BULLETIN #1 of 2024. February 15, 2024

IBSOPHONE

CHANGE OF PRODUCT UW-connector for Ibsophone

Picture 1. Seacon connector

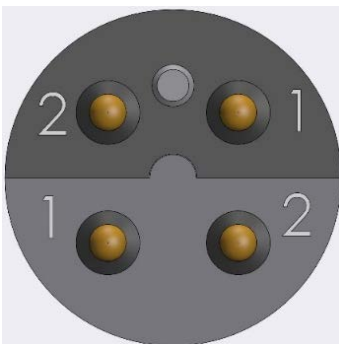
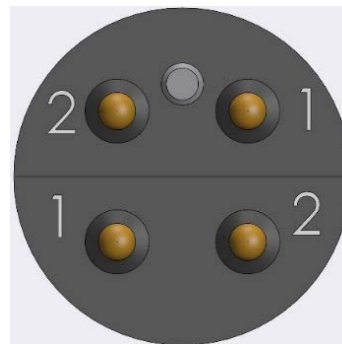
The underwater connector previously used for our lifelines, communication cables, microphones and bone conductors from Seacon has been exchanged in favor of underwater connectors from Subconn.

The underwater connector from Subconn is compatible with the one from Seacon, which means that the old products will work together with the new products with underwater connector from Subconn.

The only interference is a bulge on the microphone cable which may affect the use of an old microphone together with a new bone conductor.
